List of Approval Conditions

Application No. A/TKO/68-1

Application Site : Area 86, Tseung Kwan O

Subject of Application : Application for Class B Amendments – Comprehensive Commercial and Residential Development

BLOCK PLAN

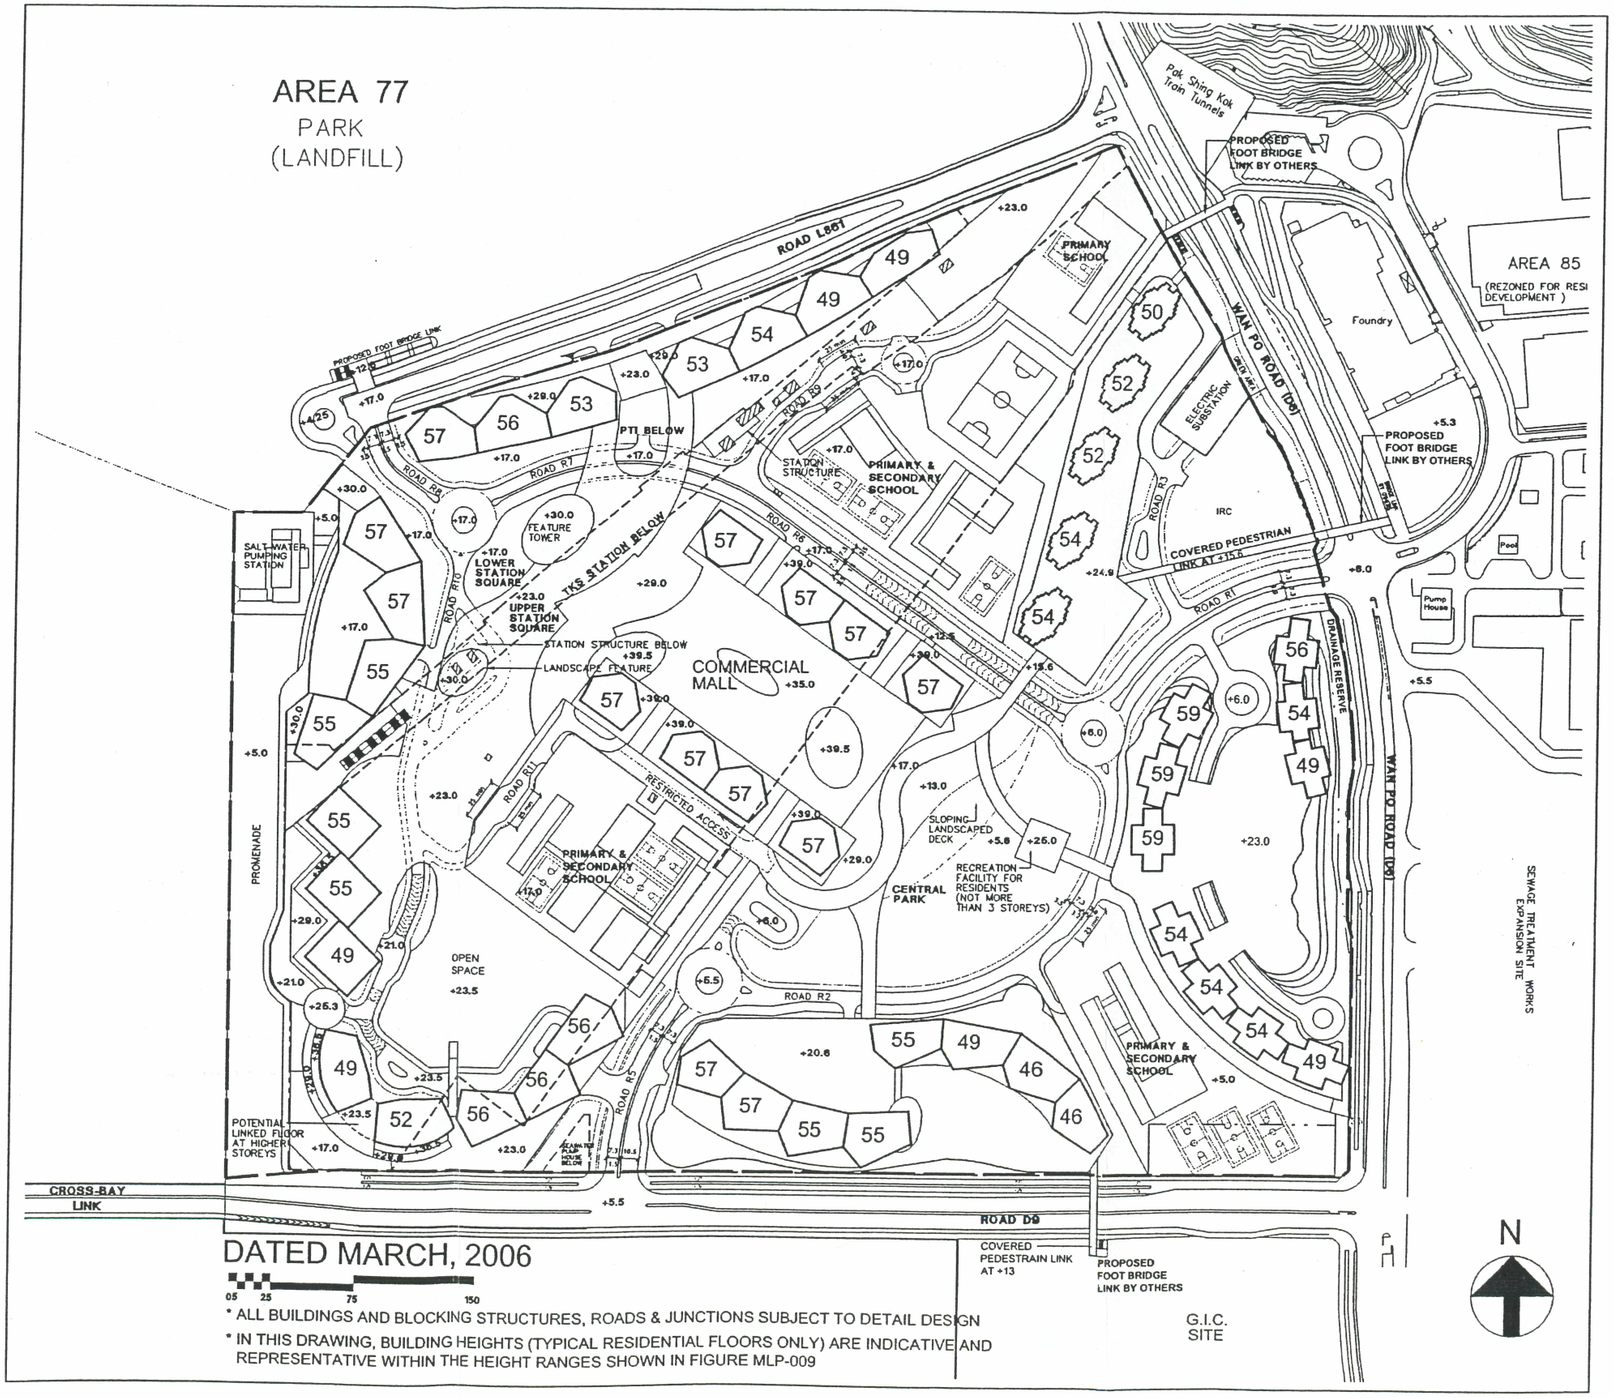
(a) the submission and implementation of a revised Master Layout Plan (MLP) and development schedule to take into account the approval conditions (b), (c) and (e) to (ae) below to the satisfaction of the Director of Planning or of the TPB;

THIS MLP WILL BE SUBJECT TO CHANGE TO INCORPORATE THE REQUIREMENTS OF THE APPROVAL CONDITIONS

Appendix 4.2f
Landscape Master Plan

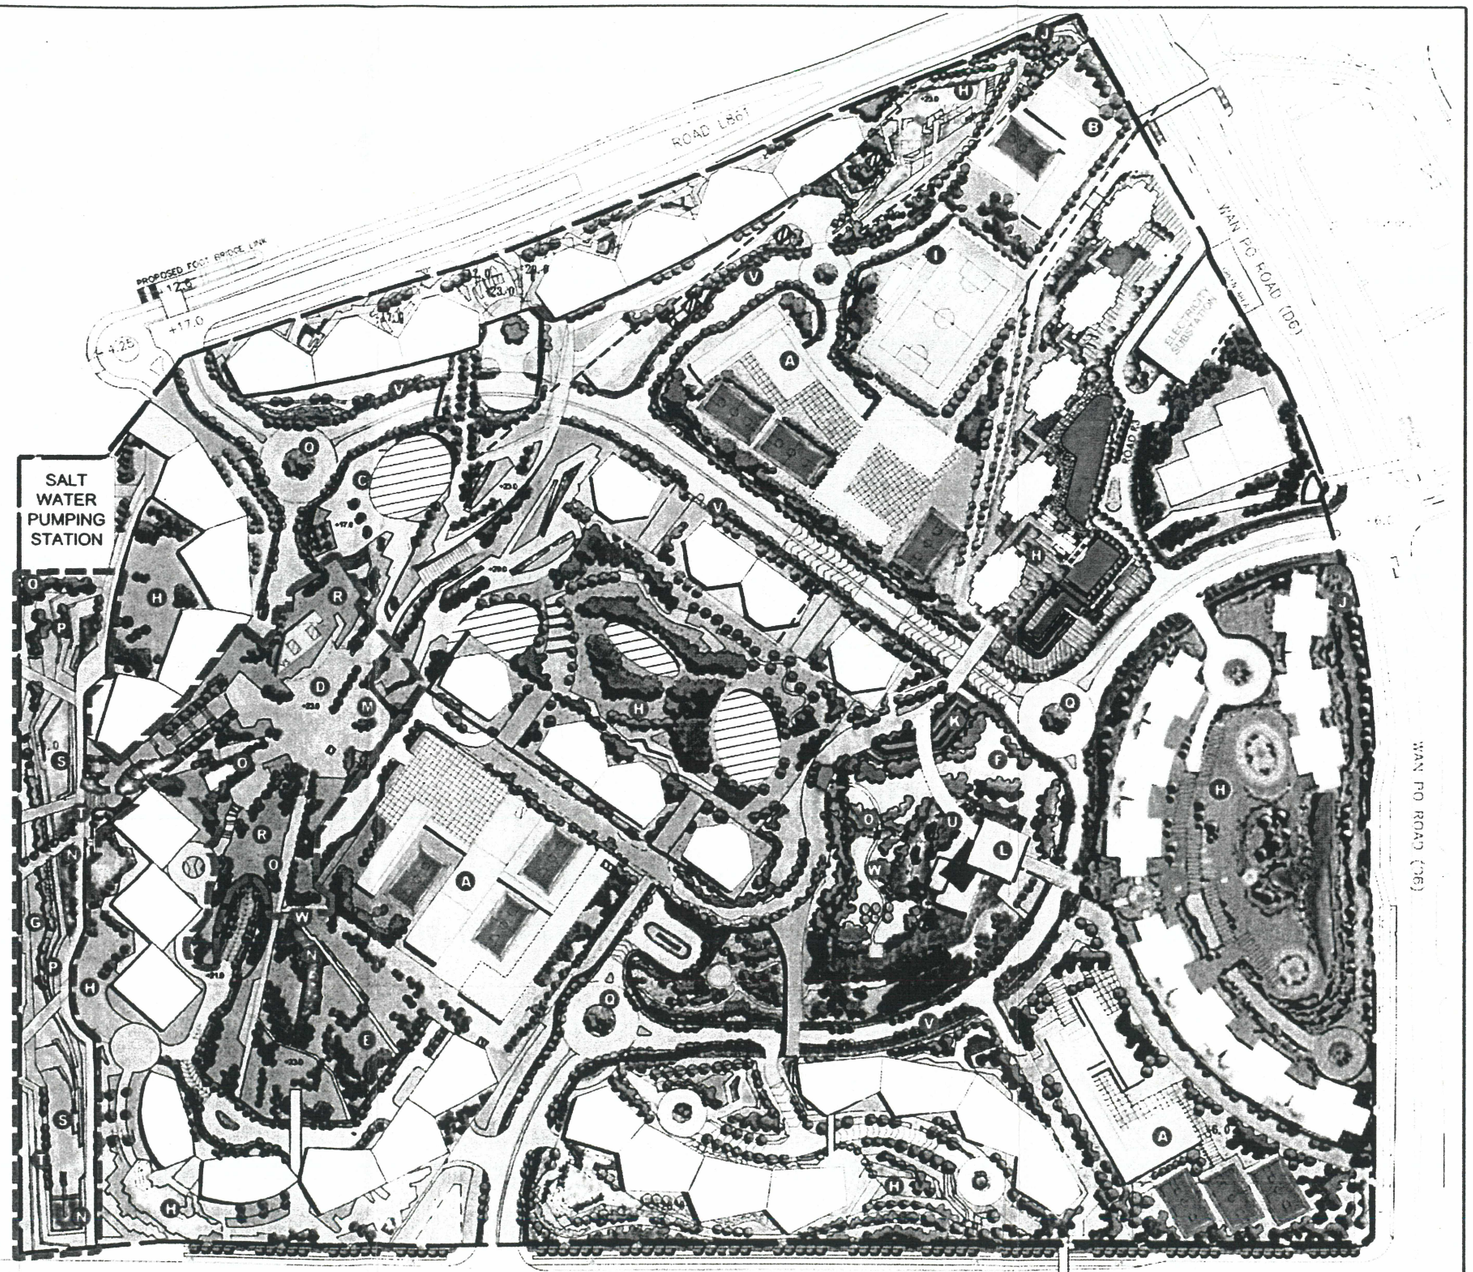
(b) the submission and implementation of a revised landscape master plan to the satisfaction of the Director of Planning or of the TPB;
